<i>Q</i>			
	Application N	o. Applican	t(s)			
	10/699,833	HORIUCH	HI, NORIYUKI ,			
Office Action Summary	Examiner	Art Unit				
	Paul Royal	3611				
The MAILING DATE of this communication appears on the cover sheet with the correspondence address Period for Reply						
A SHORTENED STATUTORY PERIOD FOR REPLY IS SET TO EXPIRE 3 MONTH(S) FROM THE MAILING DATE OF THIS COMMUNICATION. - Extensions of time may be available under the provisions of 37 CFR 1.136(a). In no event, however, may a reply be timely filed after SIX (6) MONTHS from the mailing date of this communication. - If the period for reply specified above is less than thirty (30) days, a reply within the statutory minimum of thirty (30) days will be considered timely. - If NO period for reply is specified above, the maximum statutory period will apply and will expire SIX (6) MONTHS from the mailing date of this communication. - Failure to reply within the set or extended period for reply will, by statute, cause the application to become ABANDONED (35 U.S.C. § 133). Any reply received by the Office later than three months after the mailing date of this communication, even if timely filed, may reduce any earned patent term adj

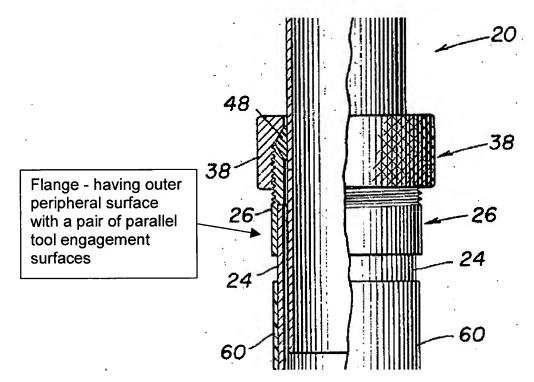
5. Claims 11-12 are rejected under 35 U.S.C. 102(b) as being anticipated by McCord, Jr. et al. (US 3,284,114).

a first tubular member (26) having a first free end, a first coupling end with a first mating adjustment structure (threads), and a first bore extending axially between the first free end and the first coupling end, the first bore having an innermost diameter that is sized to receive a tube therethrough; and

a second tubular member (38) having a second free end, a second coupling end with a second mating adjustment structure (threads), and a second bore extending axially between the second free end and the second coupling end, the second bore having an inner diameter that is sized to receive the tube there-through, the first and

the first and second tubular members (26,38) being adjustably exposed when adjustably coupled such that an overall effective length of the first and second tubular members can be changed in an assembled state,

the innermost diameter of the first bore of the first tubular member (26) being substantially identical to the innermost diameter of the second bore of the second tubular member (38),

wherein the first tubular member (26) includes a flange (see Examiner's annotated Figure 1) located at the first free end, the flange having an outer peripheral surface with a pair of tool engagement surfaces.

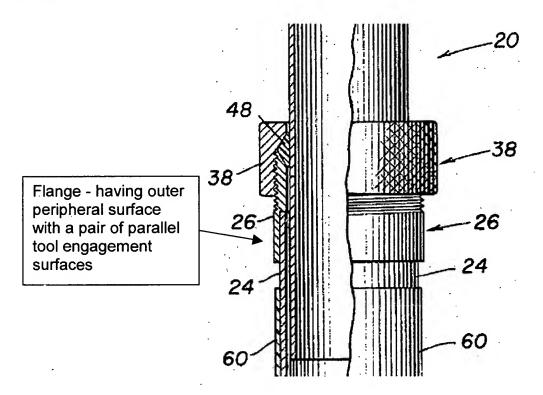
a locking member (48) configured and arranged to be selectively set to prevent relative adjustment between the first and second mating adjustment structures,

the locking member including a split locking collar having an adjustable inner diameter (the split allows the diameter to adjust) diameter, a first tapered surface (56) that engages the first tubular member (26), and a second tapered surface (54) that engages the second tubular member (38), the first and second tapered surfaces being configured and arranged to apply an axial force on the first and second tubular members,

the first and second tubular members (26,38) being adjustably exposed when adjustably coupled such that an overall effective length of the first and second tubular members can be changed in an assembled state,

wherein the first threads are external threads formed on an outer surface of the first tubular member (26), and the second threads are internal threads formed on an inner surface of the second bore of the second tubular member (38),

the innermost diameter of the first bore of the first tubular member (26) being substantially identical to the innermost diameter of the second bore of the second tubular member (38),

wherein the first tubular member (26) includes a flange (see Examiner's annotated Figure 1) located at the first free end, the flange having an outer peripheral surface with a pair of tool engagement surfaces.
